Access Compliance Report Public Rights-of-Way (Curb Ramps)

Main Street: **HAMER_DR** Cross Street: **CARTLEN_DR** Location: **SW**

ADA ID: **RPAT220223095352** Ramp Type: **Type 3 - Combination 1** Initial Pass/Fail: **Fail** Overall Compliance: **No** Severity Score: **0**

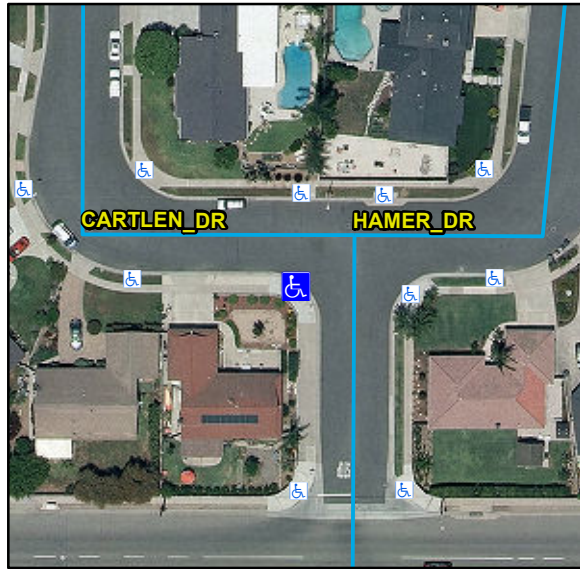
Compliance	Description	Data	Compliance	Description	Data
N/A	Ramp Length LT (in)	52	N/A	Ramp Length RT (in)	72
Yes	Ramp Width LT (in)	82	Yes	Ramp Width RT (in)	52
Yes	Ramp Run Slope LT (%)	2.2	Yes	Ramp Run Slope RT (%)	5.9
Yes	Ramp Cross Slope LT (%)	0.4	No	Ramp Cross Slope RT (%)	2.1
N/A	Ramp Length (in)	61	N/A	Flare Type LT	
Yes	Ramp Width (in)	48			N/A
Yes	Ramp Run Slope (%)	6.7	N/A	Flare Slope LT (%)	N/A
Yes	Ramp Cross Slope (%)	1.6	N/A	Flare Traversable LT	N/A
N/A	Landing Present	N/A	N/A	Flare Type RT	
N/A	Landing Length (in)	N/A			N/A
N/A	Landing Width (in)	N/A	N/A	Flare Slope RT (%)	N/A
N/A	Landing Run Slope (%)	N/A	N/A	Flare Traversable RT	N/A
N/A	Landing Cross Slope (%)	N/A	N/A	DWS Provided	N/A
N/A	Landing Movement Obstructed?	N/A	N/A	DWS Contrast	N/A
	Landing Movement Type	N/A	N/A	DWS Length (in)	N/A
N/A	Landing Shared	N/A	N/A	DWS Full Width	N/A
N/A	Clear Space	No		DWS Offset Type	N/A
N/A	Clear Space To Crosswalk (in)	N/A	N/A	DWS Offset Left (in)	N/A

Remove & Replace Curb Ramp With Two New Directional Ramps or Equivalent.

R304.2.2, R304.5.3, STD 1115
